SITE PLAN AMENDMENT
FAIRWAY VIEW VILLAGE CONDOMINIUM

FIELDSIDE LANE
WELLS, MAINE

1"=20' DATE 4/3/23 SHEET 6A

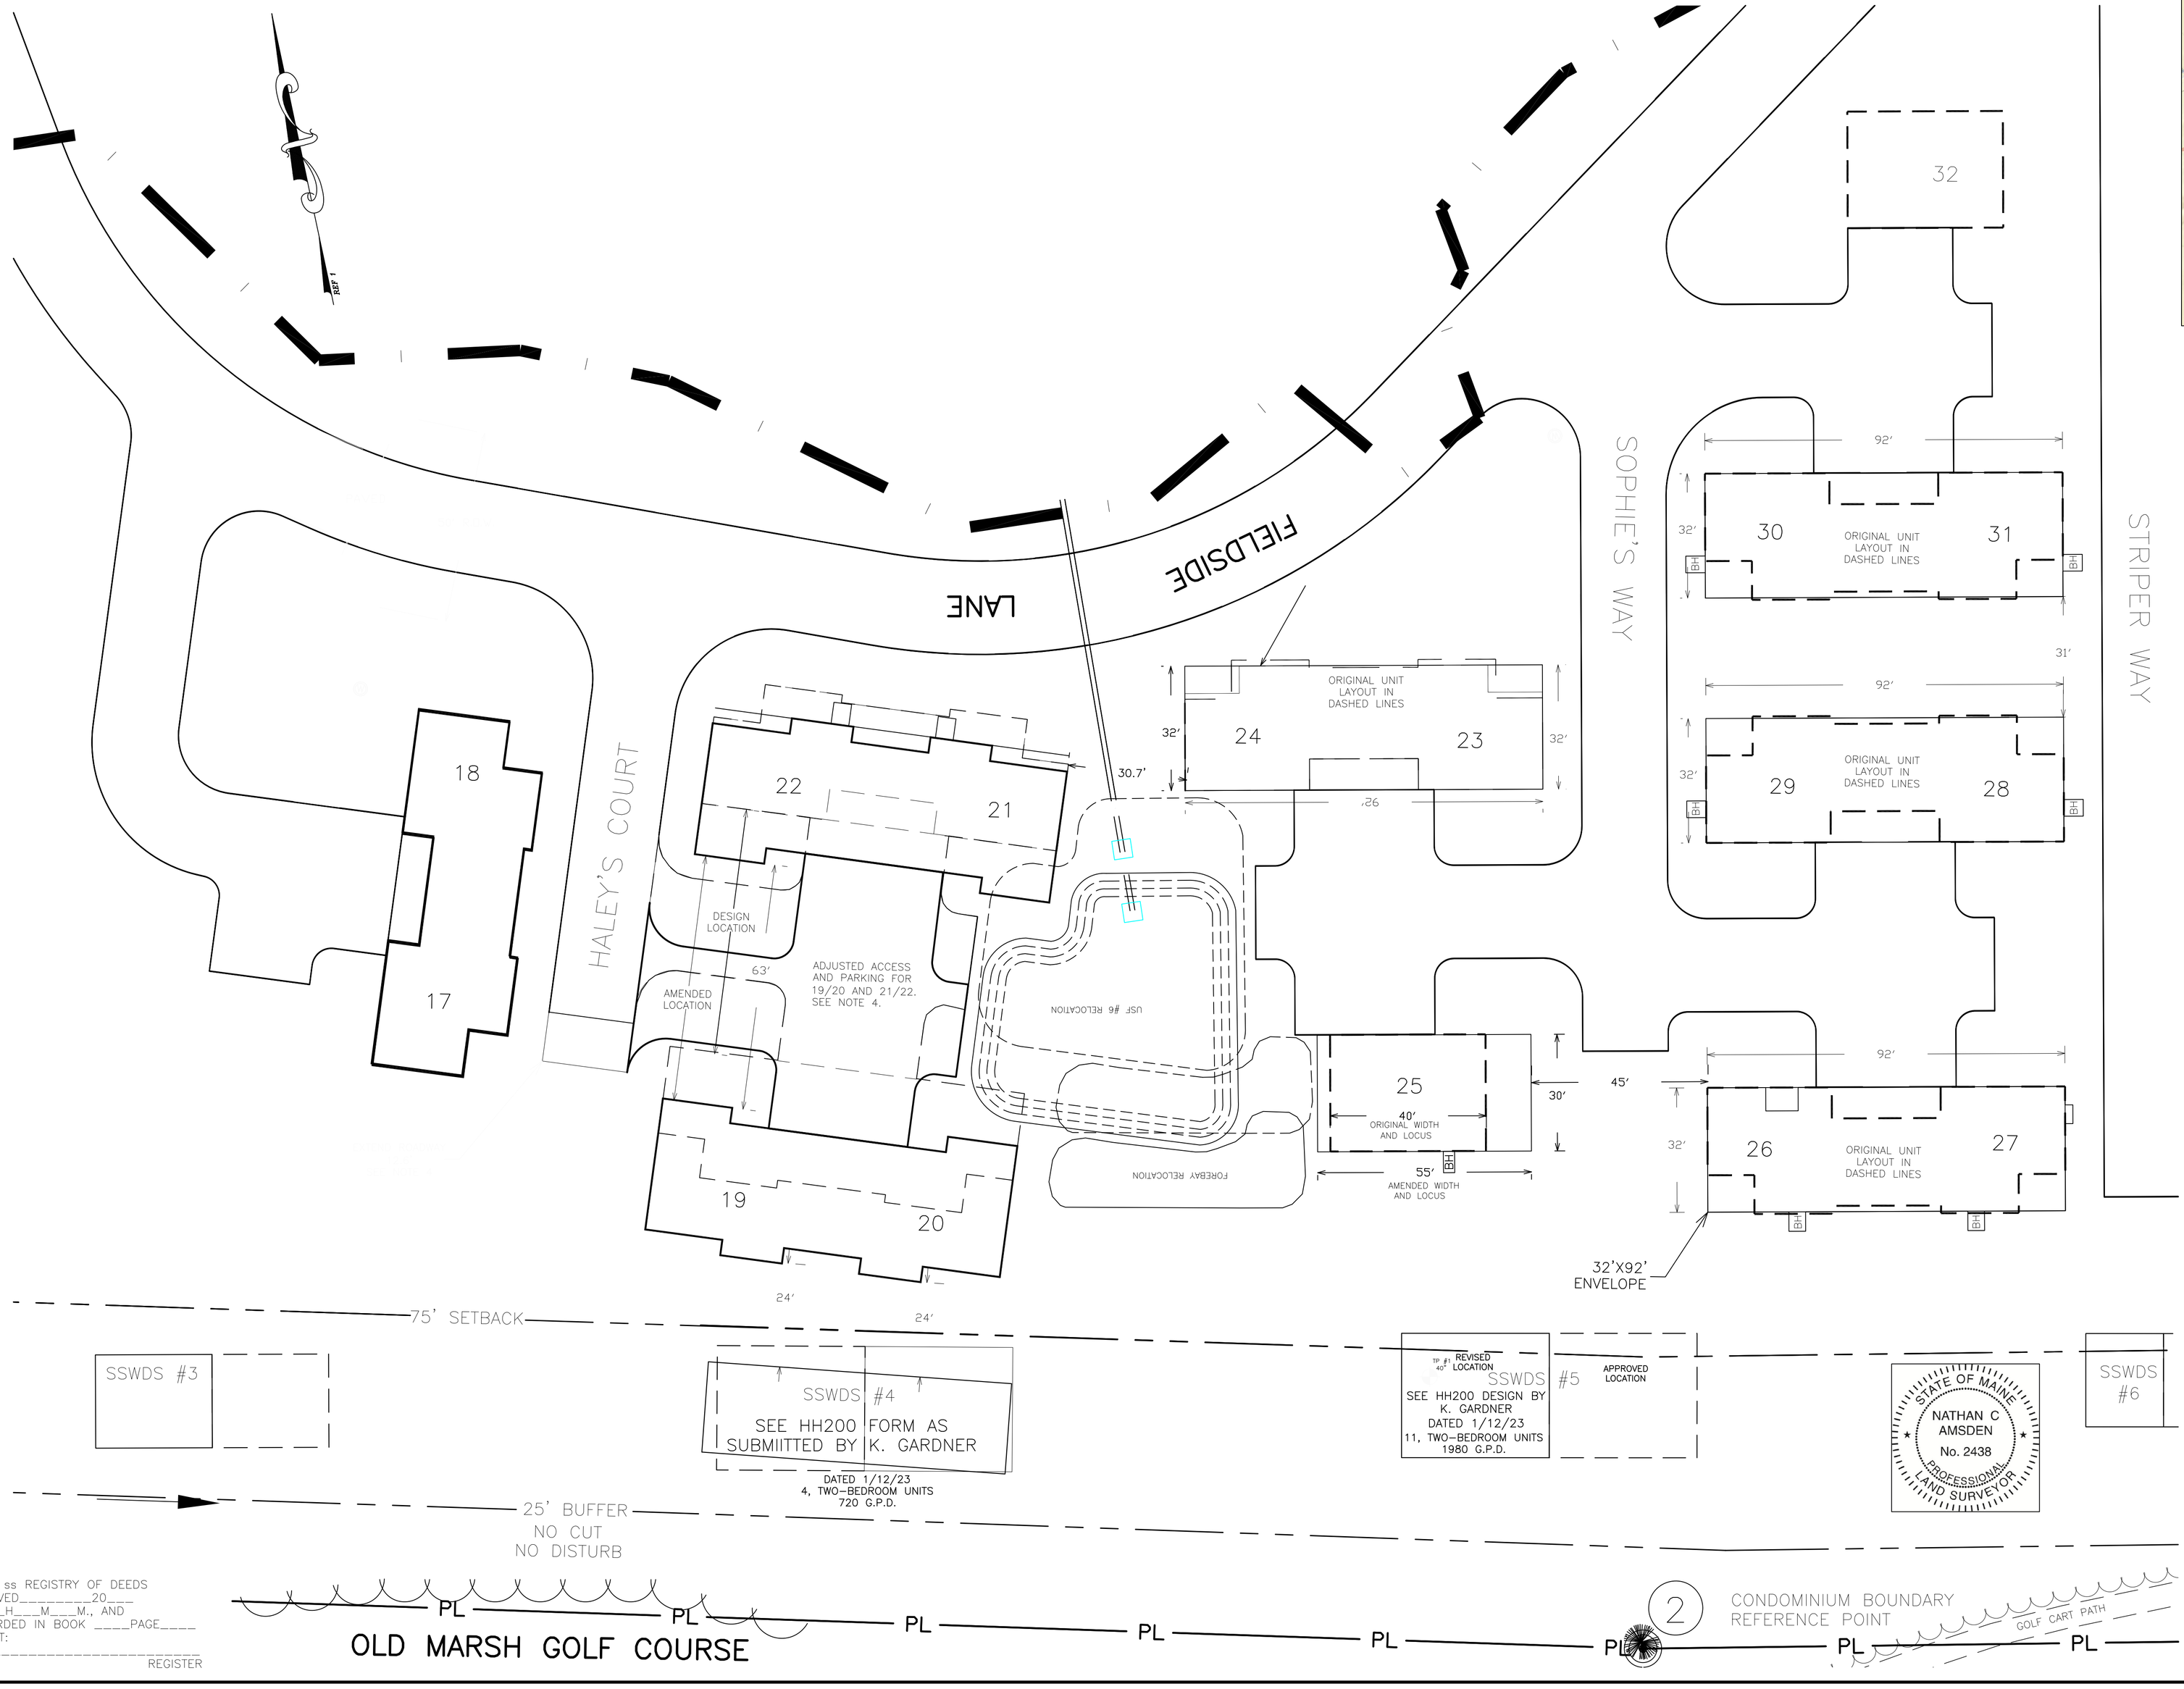
2. SEE DECLARATION OF FAIRWAY VIEW VILLAGE CONDOMINIUM RECORDED AT YORK COUNTY REGISTRY OF DEEDS.
3. THIS AMENDMENT IS TO BE PART OF THE PLAN SET UNDER REF.1 AND REF. 2 THAT HAS BEEN SUBMITTED TO THE TOWN OF WELLS. THIS PLAN IS LABELED AS SHEET 6A, AND IS TO BE AN AMENDMENT TO SHEET 6 OF THE ORIGINAL SUBMISSION. SHEET 6 IS TITLED "GRADING AND UTILITY PLAN PI.4".

4. THE PURPOSE OF THIS AMENDMENT IS TO:
   - *CREATE A BUILDING ENVELOPE AT EACH UNIT SITE WITHIN WHICH DIFFERENT MODELS MAY BE CONSTRUCTED. THIS ENVELOPE WILL BE APPLIED TO UNITS 23 THROUGH 46.

- *PORTRAY UPDATED AS-BUILT LOCATIONS FOR UNITS 19/20, 20/21, AND THE PROPOSED FULL WIDTH OF 63' FOR THEIR ASSOCIATED ACCESS WAYS AND PARKING AREAS.

- *PORTRAY A REVISED LOCATION OF FILTER POND #6 AND ITS ASSOCIATED STRUCTURES. SEE SHEET 16 OF THE ORIGINAL PLAN SET FOR DETAILS OF POND #6.
   - *PORTRAY A REVISED BUILDING ENVELOPE FOR UNIT #25.

- *EXTEND HAYLEYS COURT BY 12.6' TO ACCOMODATE THE NEW LOCATION OF UNITS 19/20 AND 21/22.
5. THE AMENDED POSITIONS AND DIMENSIONS OF UNITS 19/20 AND 21/22, AND THE NECESSARY EXTENSION OF HALEY'S COURT WILL RESULT IN A NET INCREASE IN IMPERVIOUS AREA OF 1,303 S.F.
